**Cloudbreak Life of Mine Project
— inquiry under s46 of the
Environmental Protection Act 1986
to amend Ministerial Statement 899**

Report 1498

January 2014

**CLOUDBREAK LIFE OF MINE PROJECT – INQUIRY UNDER S46 OF THE
ENVIRONMENTAL PROTECTION ACT 1986 – CHANGES TO
CONDITIONS 7-1 AND 7-2 OF MINISTERIAL STATEMENT 899
(ASSESSMENT NO. 1980)**

Figure 2 Locations of monitoring bores within the Project Area

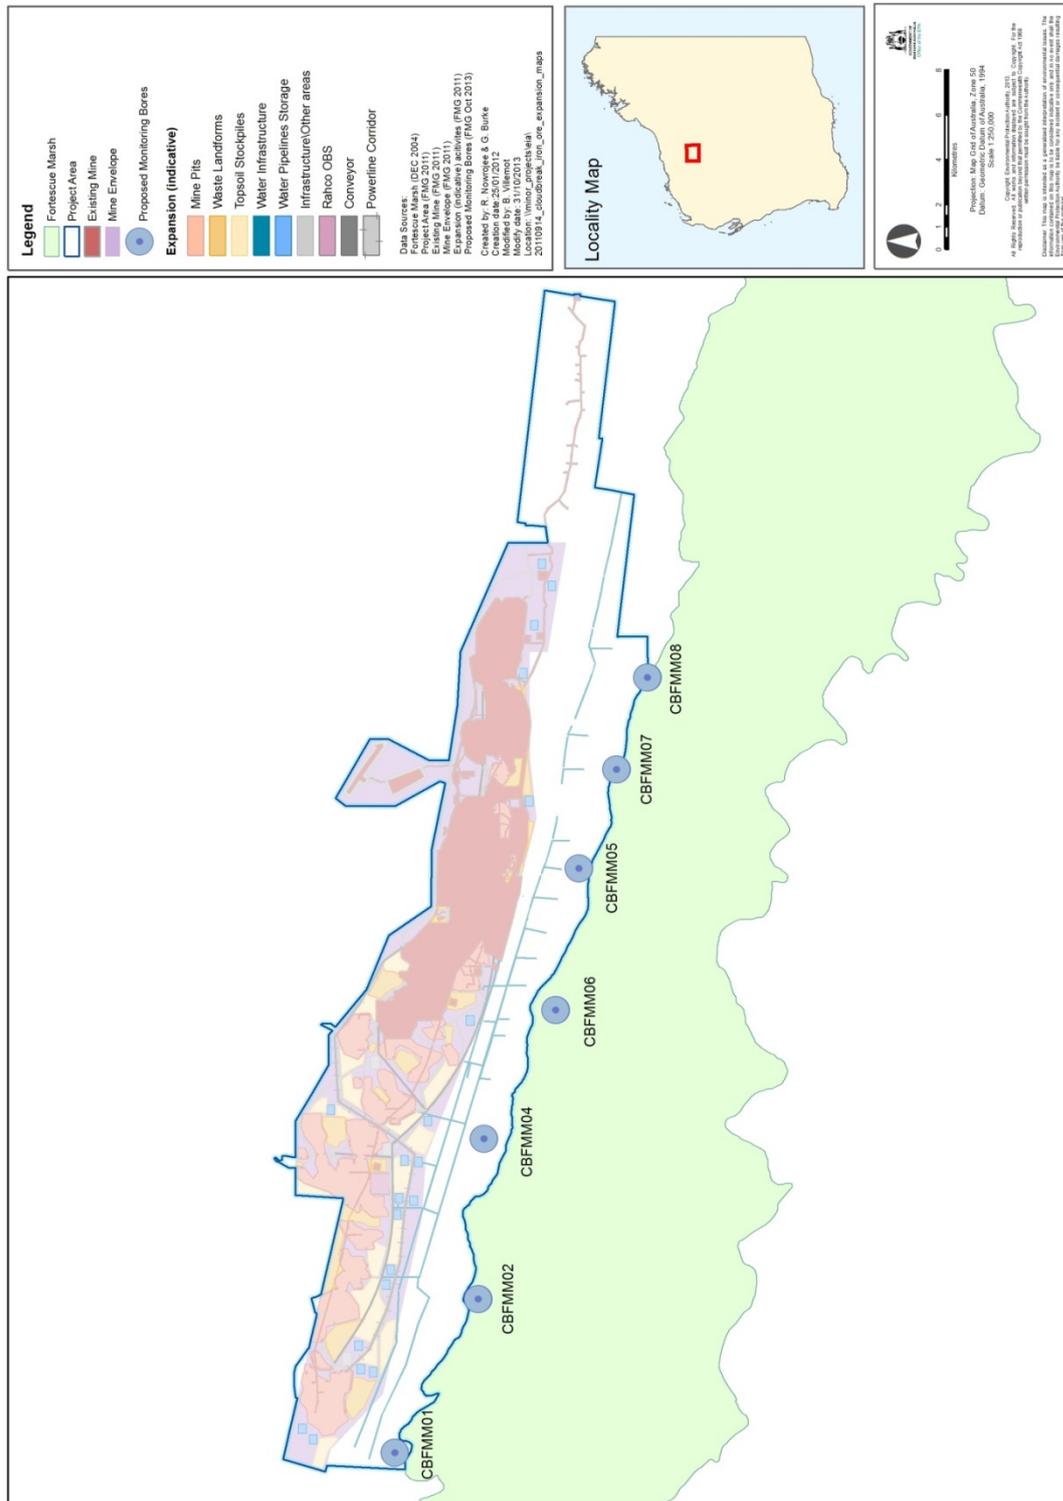
Replace Figure 2 with figure showing new monitoring bores below

groundwater level, using a suitable network of bores at the fringe of the Fortescue Marsh as shown in Figure 2 and delineated by co-ordinates in schedule 2, having regard for climatic trends and seasonal variation, unless prior written authorisation of the CEO has been received.
